ATTACHMENT 10

Revised Architectural Drawings prepared by NG Sanders & Associates

ATTACHMENT 11

Revised Landscape Concept Package
prepared by Saunders Havill Group

SECTIONS

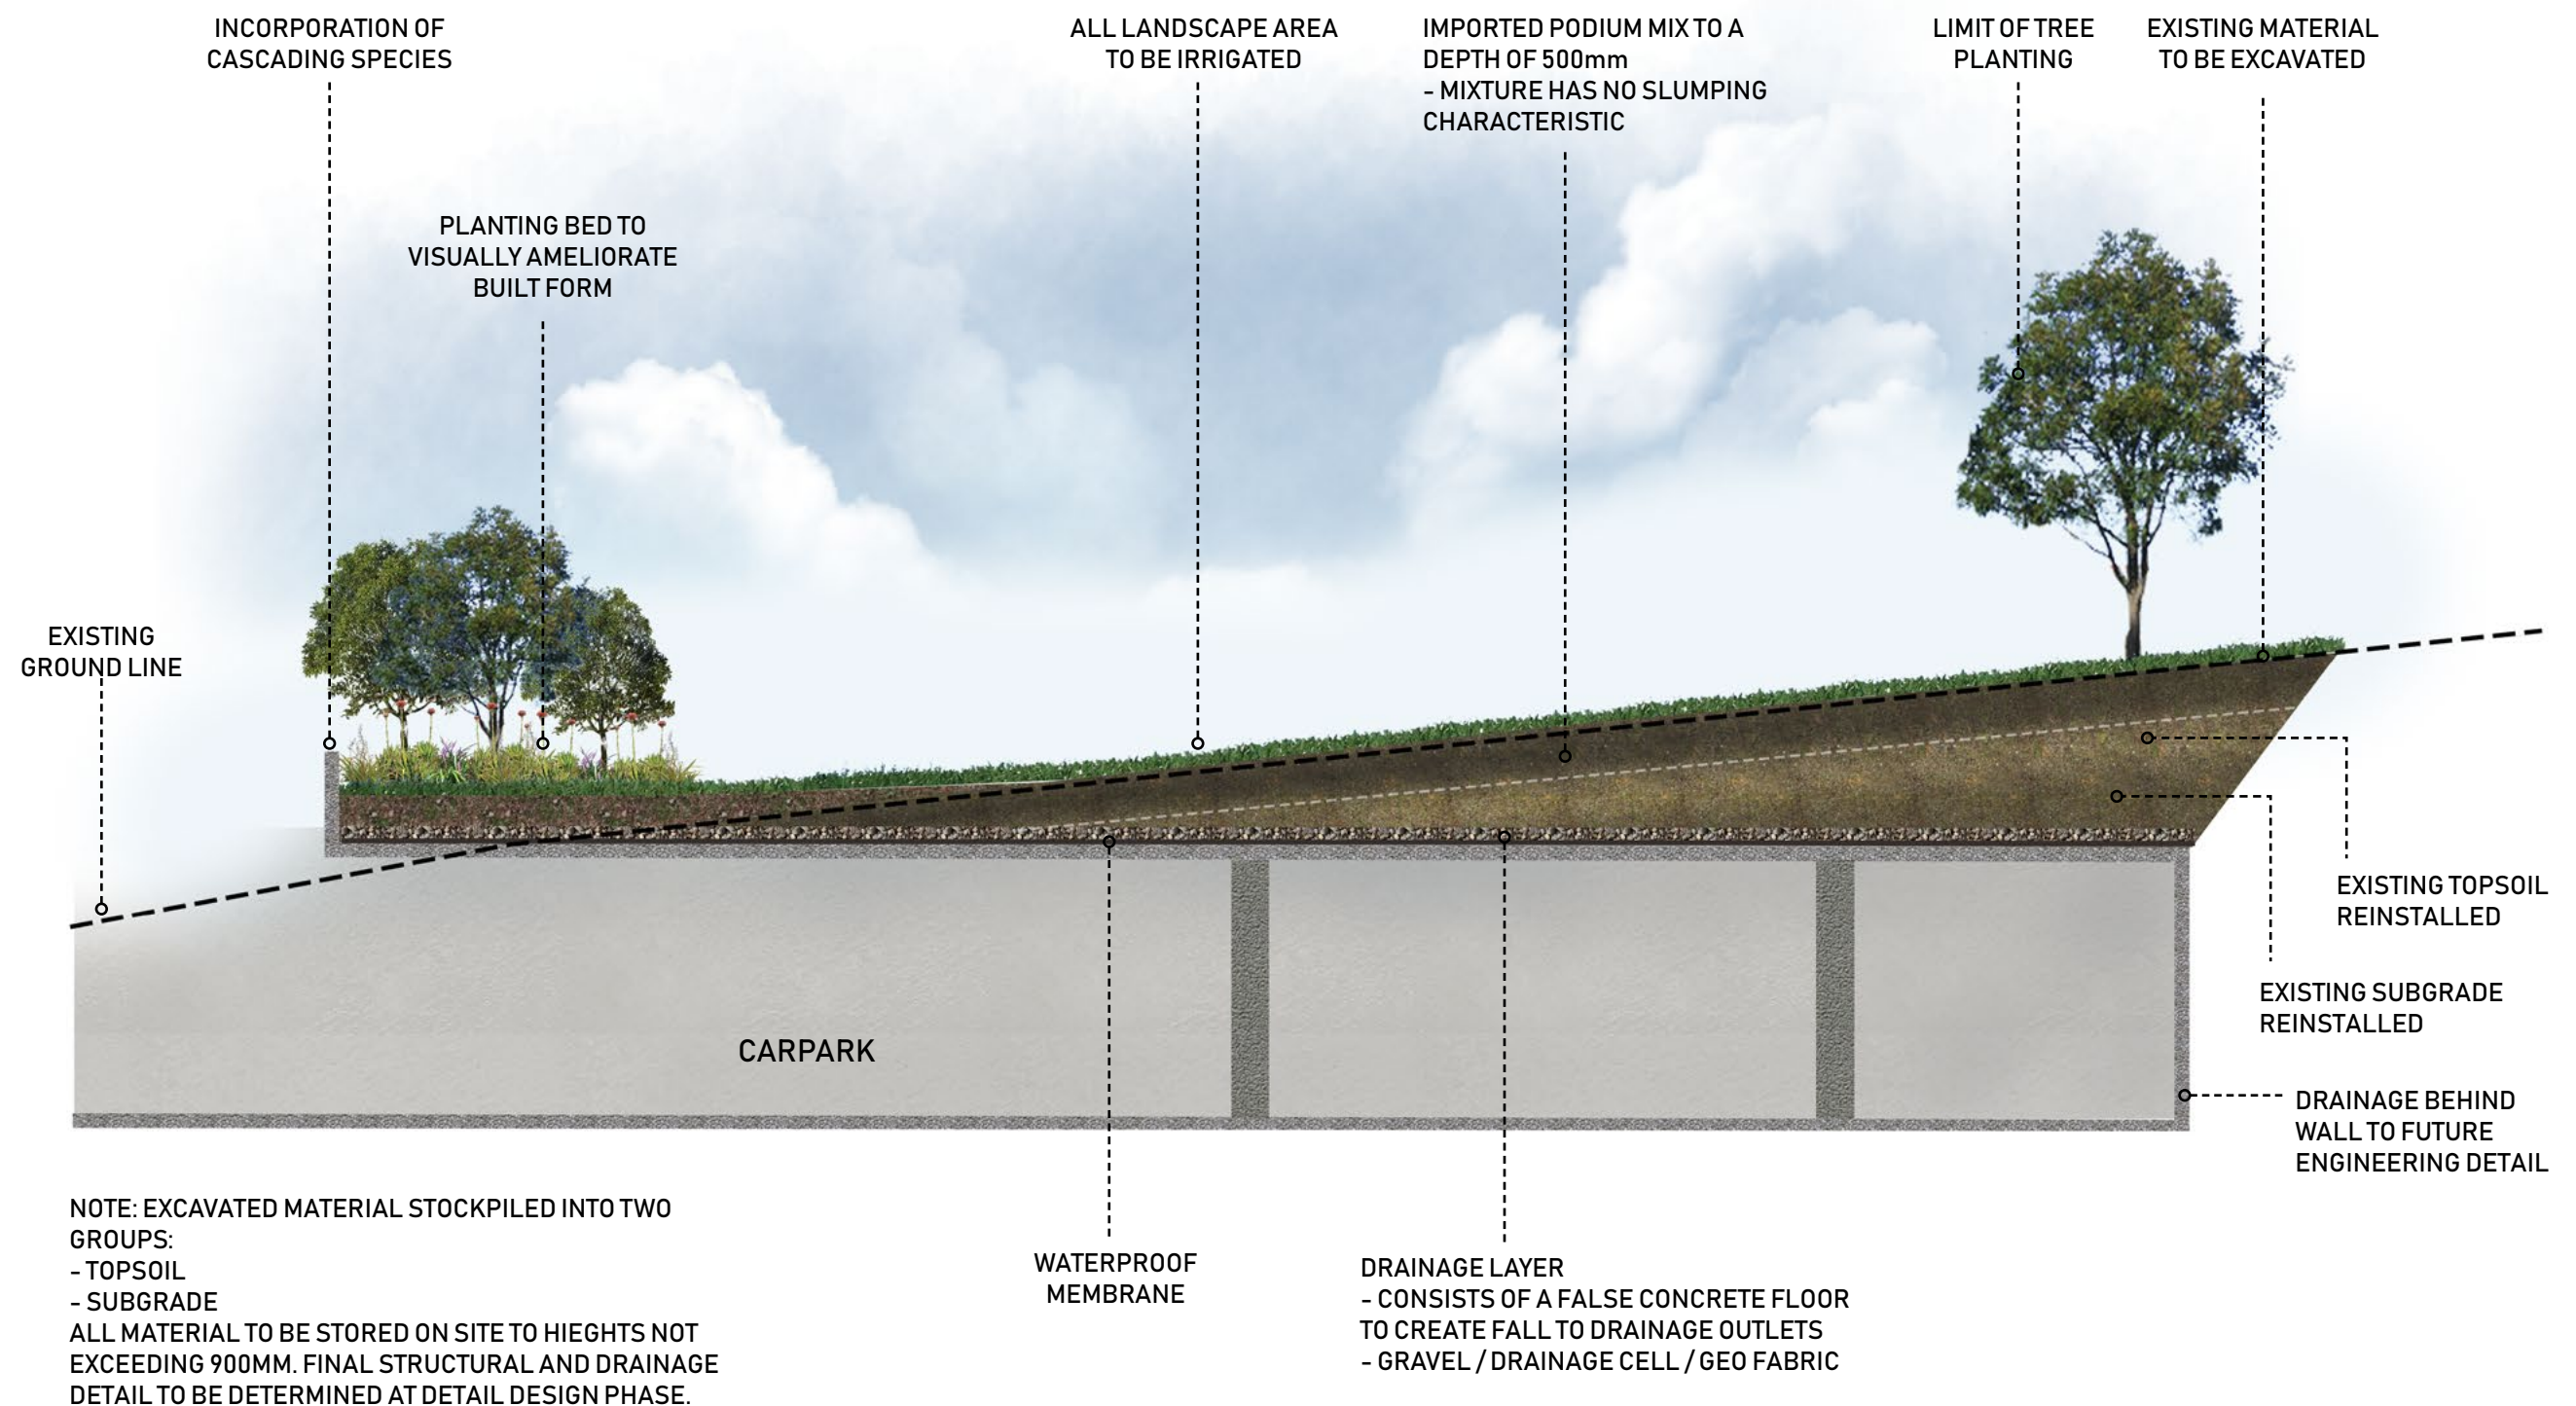
Cross sectional elevations to show the grades of batters and associated heights at the interface with the development;	Refer civil for design grade sections – the section within the updated landscape concept package depicts the interface between the bio basin and the recreation linkage corridor, however, connection between the recreation linkage corridor and the development is intended to be at a manageable grade.
